# Technical Design Note

**Project:** Proposed Kings Hill development

**Subject:** Traffic review for internal roads

The layout of the two options tested is provided below:

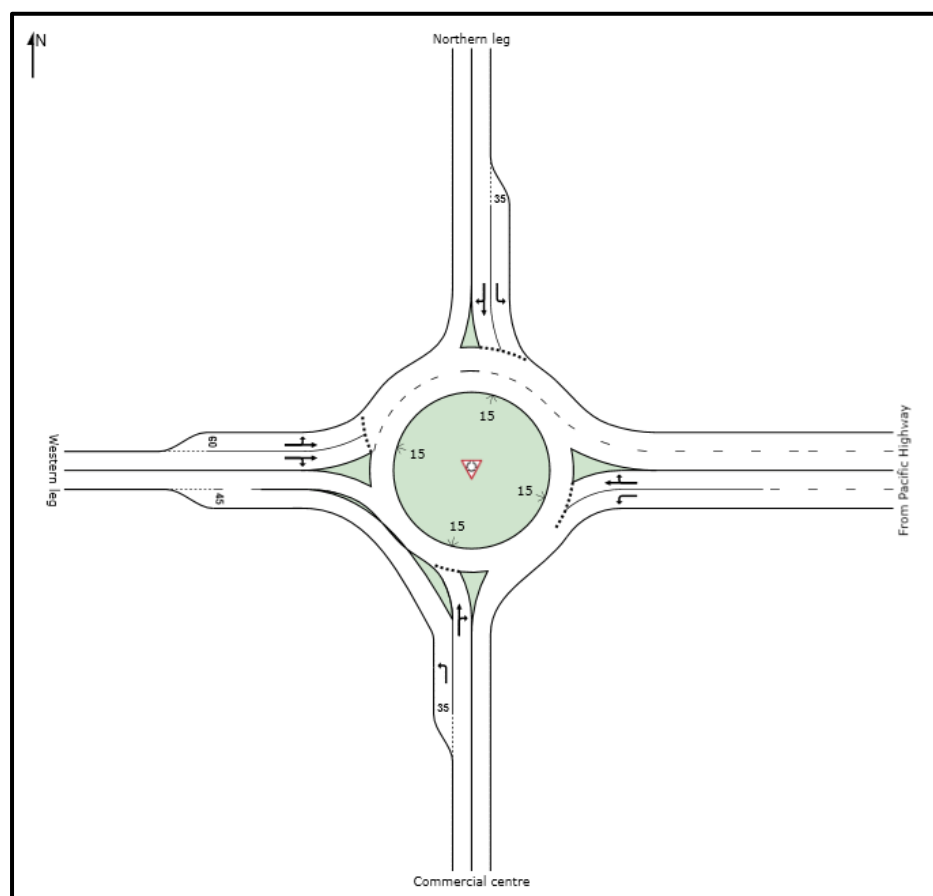
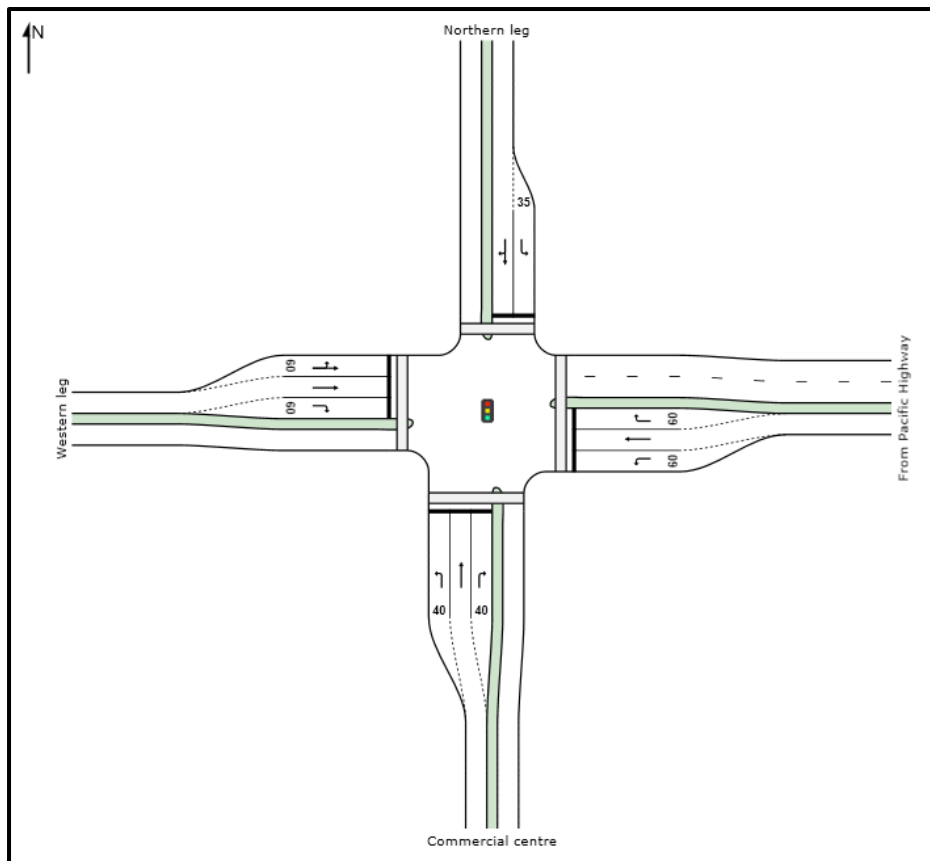
Based on the results above, it can be seen that the proposed roundabout offers a better operational environment, with reduced delays and queues. It is also noted that out of the peak hour, when the traffic flows are lower, the delays for road users for the roundabout option would be negligible, whilst there would be delays created by the traffic signals at this time, due to a driver potentially arriving at the signals just after a green phase and having to sit and wait for the signals to complete their cycle before getting a green signal.

However, a roundabout is not as safe or convenient for cyclists or pedestrians compared with traffic signals where a dedicated phase can be provided for both cyclists and pedestrians.
